World Forum for Harmonization of Vehicle Regulations

Proposal for Supplement 10 to the 04 series of amendments to Regulation No. 48 (Installation of lighting and light- signalling devices)

Submitted by the Working Party on Lighting and Light-Signalling*

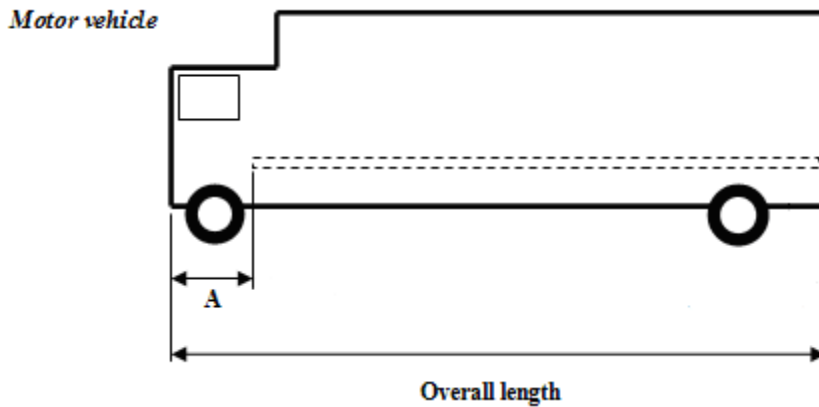
However, an alternative marking mode within 2400 mm from the front end of the motor vehicle is allowed where a series of retro-reflectors of Class IVA of Regulation No. 3 or Class C of Regulation No. 104 are mounted followed by the required conspicuity marking as follows:

- (a) Retro-reflector size minimum 25 cm²;
- (b) One retro-reflector mounted not more than 600 mm from the front end of the vehicle;
- (c) Additional retro-reflectors spaced not more than 600 mm apart;
- (d) The distance between the last retro-reflector and the start of the conspicuity marking shall not exceed 600 mm;

6.21.4.2.2.1. For motor vehicles, length of vehicle excluding the cab, or in the case of tractors for semi-trailers, if fitted, the length of the cab; however, when using the alternative marking mode per paragraph 6.21.4.2.1.1., the distance beginning within 2,400 mm from the front end of vehicle to its rear end.

A is the distance between the foremost conspicuity marking and the front end of the vehicle. The maximum value of A is 2400 mm (see paragraph 6.21.4.2.1.1.)."
